ANP-10263Q1NP
Revision 0

Response to Request for Additional Information

**ANP-10263P, Codes and Methods Applicability Report for the
U.S. EPR**

**Response to Request for Additional Information – ANP-10263P
“Codes and Methods Applicability Report for the U.S. EPR” (TAC No. MD2803)**

Figure 2-5a
Steam Generator Axial Economizer

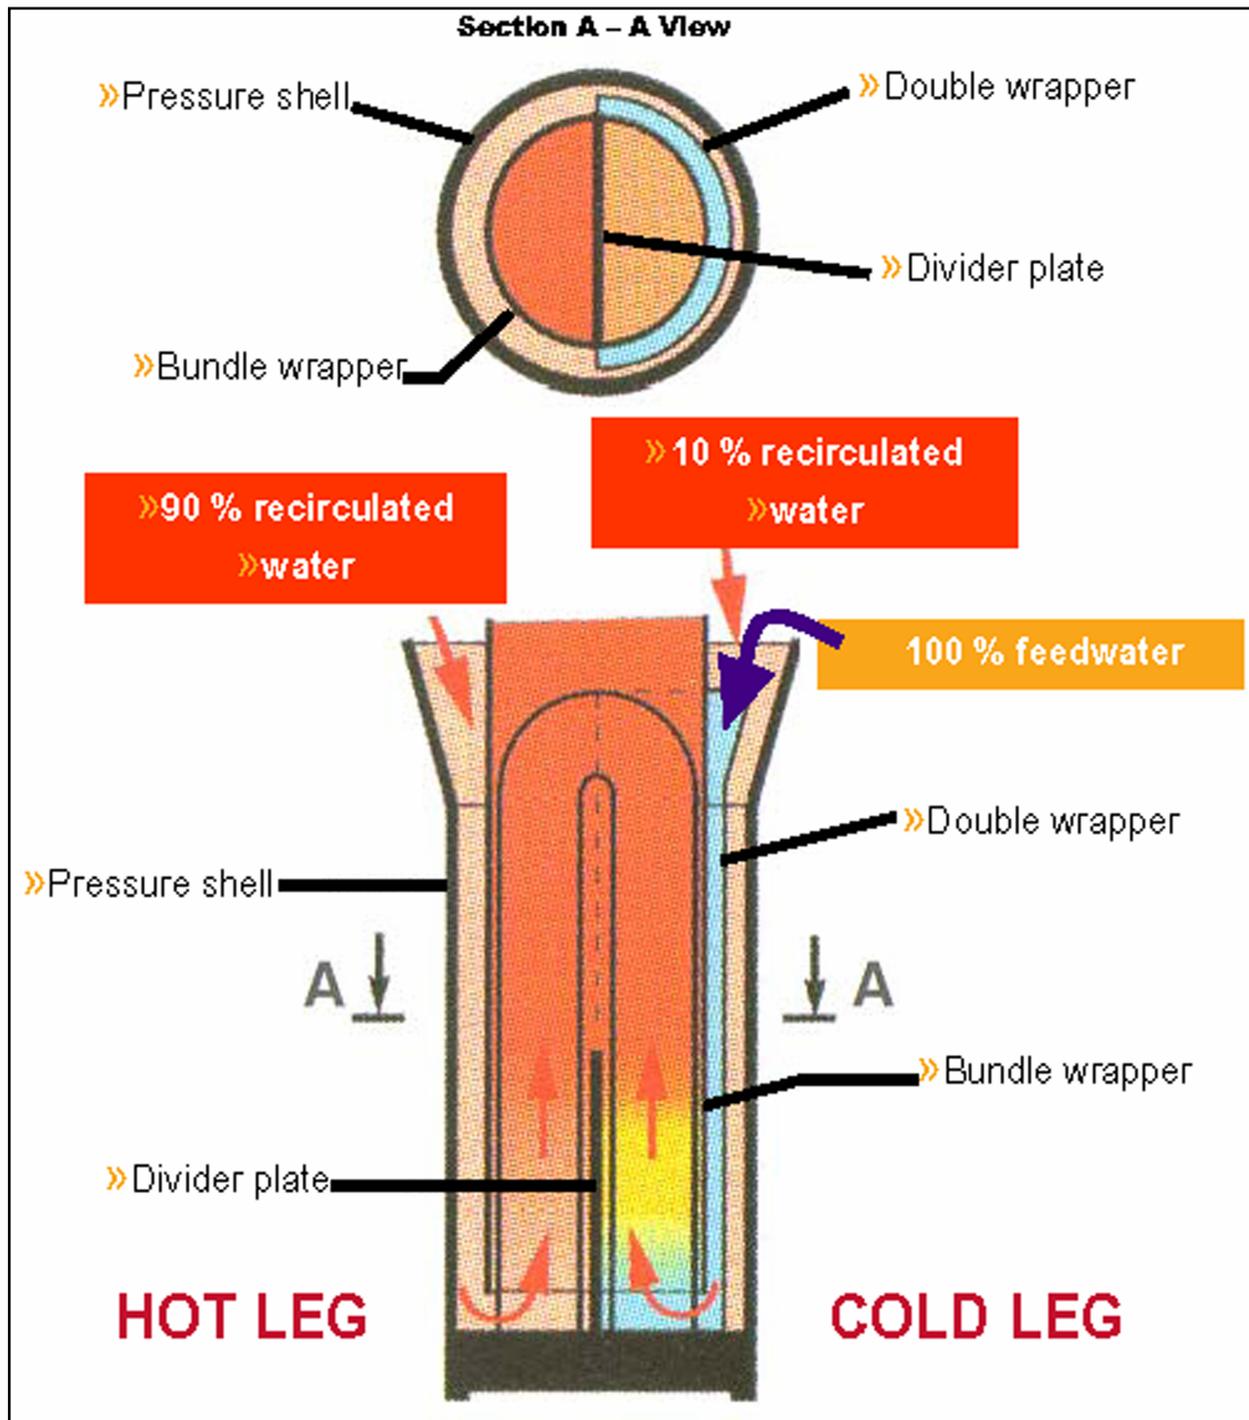
The U.S. EPR SG design includes an economizer, a feedwater preheating section (Figure 2-5 does not appear to show this feature).

RAI 2: *Provide a better pictorial representation of the economizer, both elevation and cross-section views, either replacement or additional figure. On modeling Figure 5-2, provide a cross-section view showing the economizer modeling.*

“Figure 2-5a illustrates the concept and operation of the SG axial economizer.”

The new Figure 2-5a follows this response.

Figure 7-1 MSRT Response

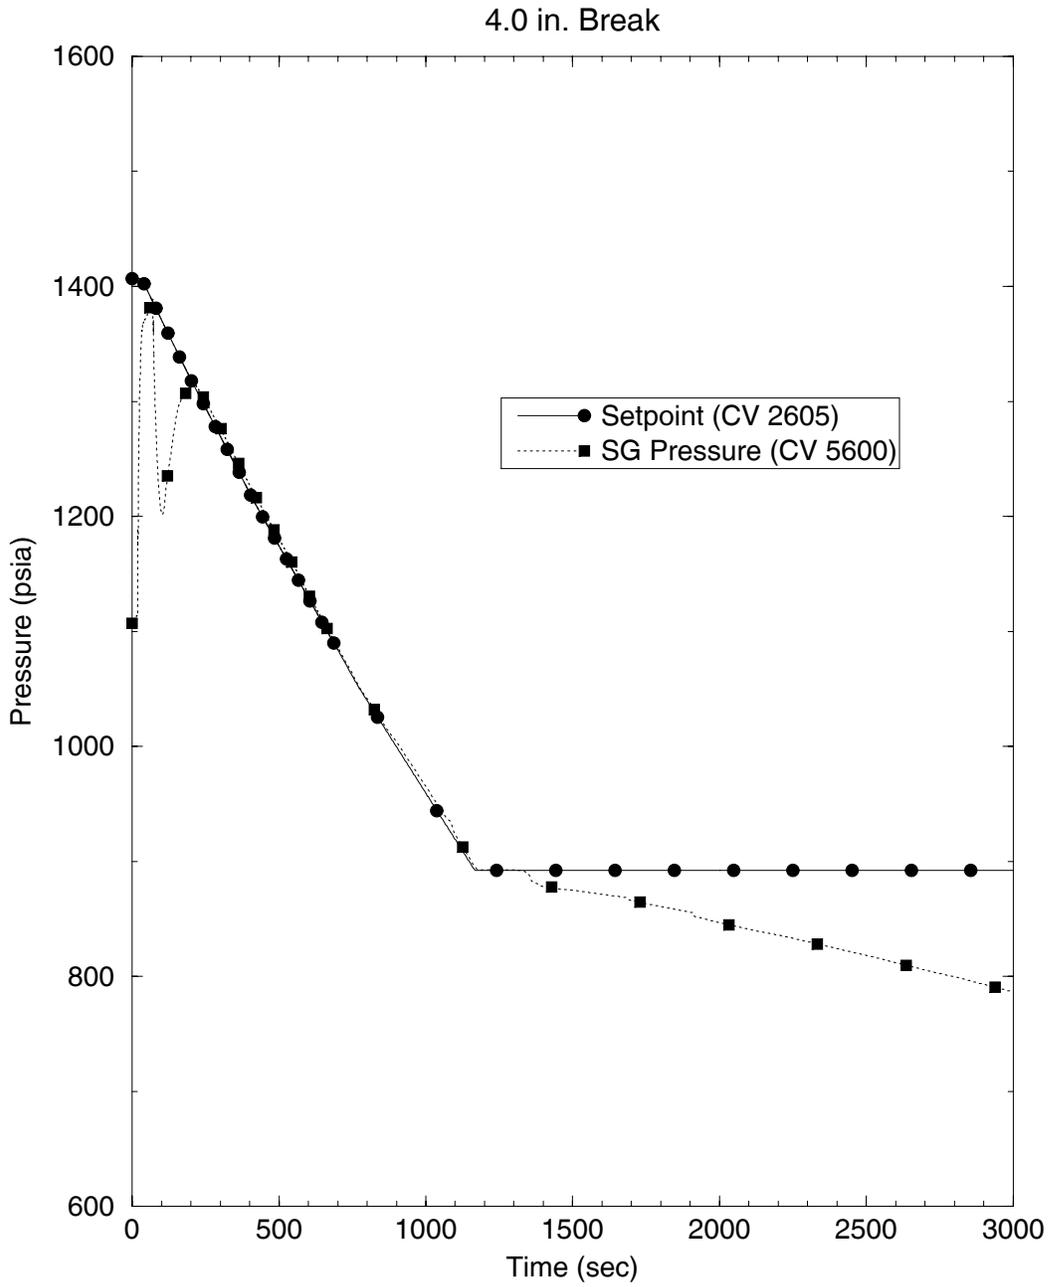
RAI 7: *Section C.2, page C-3: It is not clear where the 1406.9 psia value comes from, the graphical output does not reach this value. The post-trip set-point for the MSRT is not this high. Where does this value come from? Modify the text, or graphical output, according.*

Following a LOCA safety injection signal, the MSRT pressure control setpoint is reduced from nominally 1385.1 psia (+ 21.8 psia uncertainty = 1406.9 psia) to 870 psia (+ 22 psia uncertainty = 892 psia) at a rate corresponding to a reduction in the saturation temperature of 180 °F/h. This reduction in setpoint occurs whether the MSRIV has opened or not. Therefore, depending on the length of time elapsed from the start of cooldown and the rate that secondary pressure rises, the MSRIV may open at a pressure that is much lower than 1385.1 psia. The reduction in pressure control setpoint proceeds independently of actual secondary side pressure.

In the sample problem, SG1 secondary pressure intersects the cooldown curve at 70.8 seconds at a SG1 pressure of 1382 psia and the MSRIV opens. The opening of the valve results in a high flow through the MSRCV (which at that time is 100% open) and a drop in SG pressure of about 120 psia resulting in MSRCV modulating close. The MSRCV modulates open again at 206 seconds at a pressure in SG of 1316.1 psia. From then on the SG pressure follows the cooldown curve. Figure 7-1 presents this behavior for SG1. The other three SGs behave similarly.

Figure 11-1 Detail of Reactor Vessel Inlet Nozzle Region of Downcomer

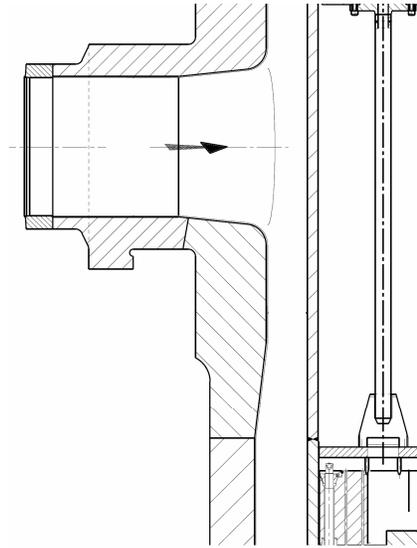
RAI 11: *It is not clear from the text or from Figure 2-4 what is meant by a variable cross-section area in the downcomer. Elaborate and include a discussion of any changes needed to ensure adequate two-dimensional (θ, z) nodalization of the downcomer for licensing analyses.*

Figure 2-4 of ANP-10263P shows a cross sectional view of the reactor vessel. The detail below (Figure 11-1) magnifies the region just below the cold leg inlet nozzle in the downcomer, showing the reactor pressure vessel (RPV) wall and the core barrel. The downcomer annulus is defined by the dimensions of these 2 boundaries.

Below the forging in the nozzle region, continuing down to the bottom of the downcomer, the lower RPV wall is thinner, resulting in an increase in the downcomer annular width. This change in the downcomer flow area is captured in the S-RELAP5 model.

The uppermost volume in the lower downcomer spans the transition in the RPV inner diameter from 15.59 ft at the nozzles to 15.98 ft for the lower wall. The flow area of this control volume is calculated based on the actual dimensions of the wall above and below the transition and the distance below the nozzles where the transition in wall thickness occurs. The uppermost volume in the ANNULUS therefore has a smaller flow area than the 3 lower volumes.

Figure 13-1 Primary and Secondary System Pressures for 4 Inch Break

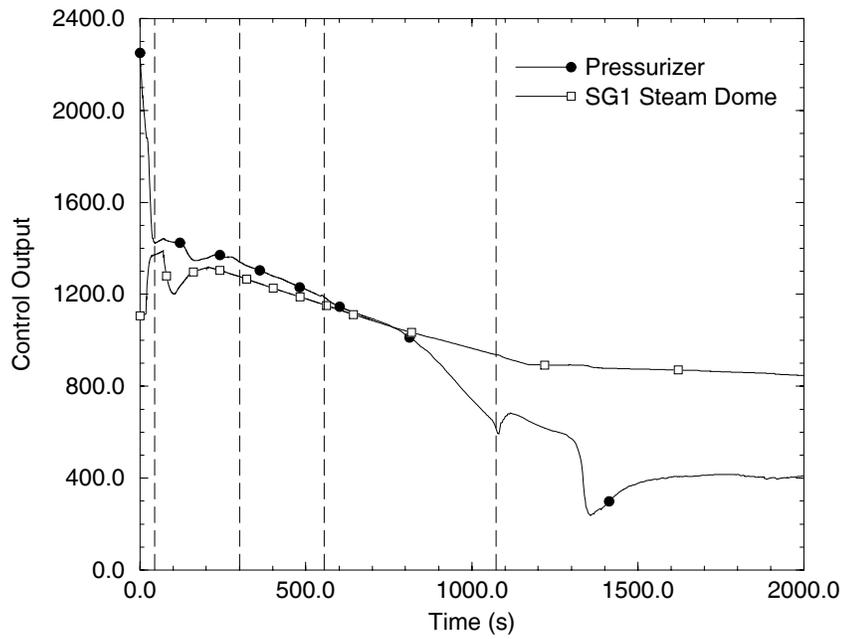
RAI 13: *The referenced benchmarks (Table 4-2) do not specifically address SG mass and heat transfer. Expand the PIRT to specifically address SG mass and heat transfer during all phases, including phenomena associated with reflux condensation. Expand the validation data base for SG mass and heat transfer, including reflux condensation, particularly to address the later phases of the event.*

Figure 13-1 shows the effects of the partial cooldown, which started just after 200 seconds and continues past 1100 seconds. At the end of loop seal clearing, the break flow transitions from low quality two-phase flow to primarily steam flow which causes the primary system to depressurize at an increased rate. The higher depressurization rate of the primary system causes the primary pressure to decrease below the secondary pressure at about 760 seconds. After this time, condensation in the steam generators ceases since the secondary temperature will be superheated with respect to the primary saturation temperature. Except for the decreasing pressures from the partial cooldown, the process is identical to those found in current PWR designs. Since mass transfer and reflux condensation in the steam generator during the boil-off and recovery periods are currently ranked as medium low importance, no change in ranking is warranted. Also, the current assessments are sufficient since no new phenomena are occurring.

Figure 21-1 Heavy Reflector

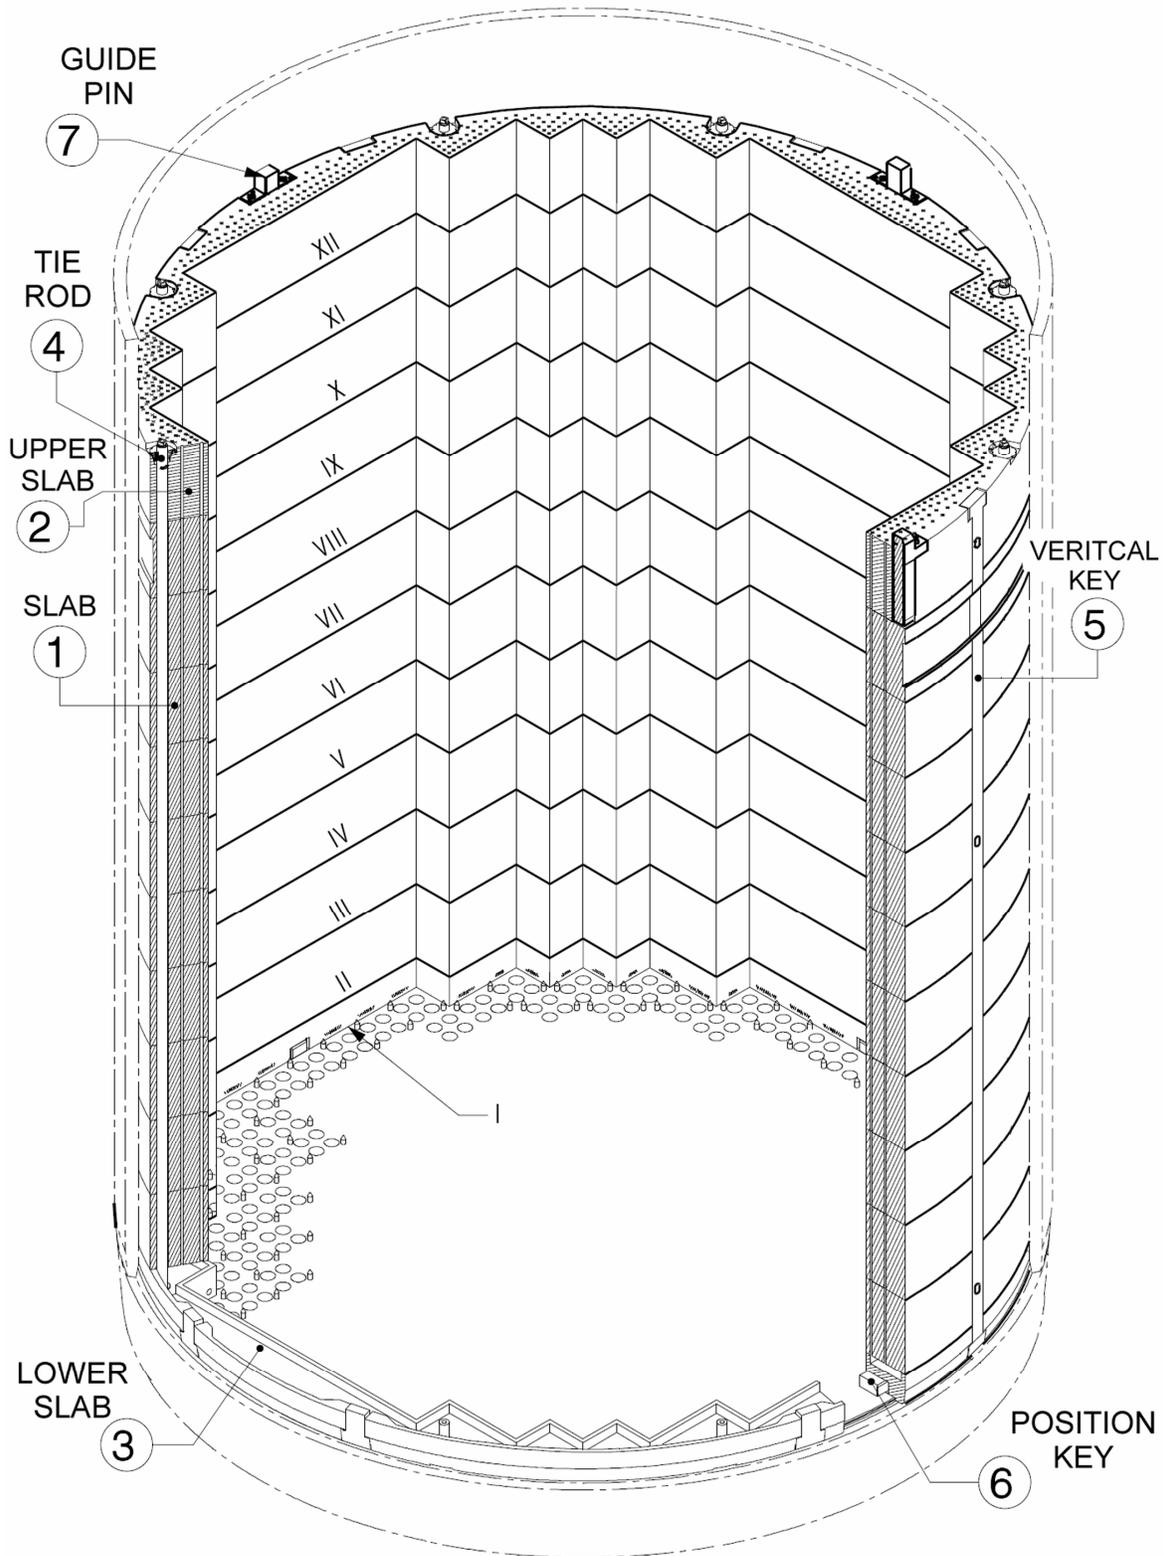
- RAI 21:** a) *Please describe the coolant flow system for these channels (number and size of the channels, and flow path from entrance to exit).*
- b) *Please provide the AREVA plans to validate the flow path modeling. Include a discussion on the entrance/exit loss factors, channel pressure drop, likelihood and consequences of steam binding (or blockage) in some or all channels, and the adequacy of the fluid flow map to model the expected flow pattern in the channels. How does blockage of these channels affect the EPR performance for AOOs, DBAs, LOCAs (large and small) and long term cooling?*

The space between the multi-cornered radial periphery of the reactor core and the cylindrical core barrel is filled with a stainless steel structure, called the heavy reflector, the purpose of which is to reduce fast neutron leakage and flatten the power distribution. The reflector is inside the core barrel above the lower core support plate. To avoid any welded or bolted connections close to the core, the reflector consists of stacked forged slabs (rings) positioned one above the other with keys, and axially restrained by tie rods bolted to the lower core support plate. (See Figure 21-1.)

A hydraulic diameter for the heavy reflector bypass region is approximated from the region flow area and the wetted perimeter of the core barrel, outer heavy reflector surface and the perimeter of all the holes. The form loss for the junctions at the entrance (from the lower reactor vessel plenum) and exit (to the upper plenum) of the heavy reflector region are estimated from an assumed pressure drop and from abrupt area change relationships. These loss coefficients are adjusted to obtain the target value of 1.24% of the total RCS flow rate through the region.
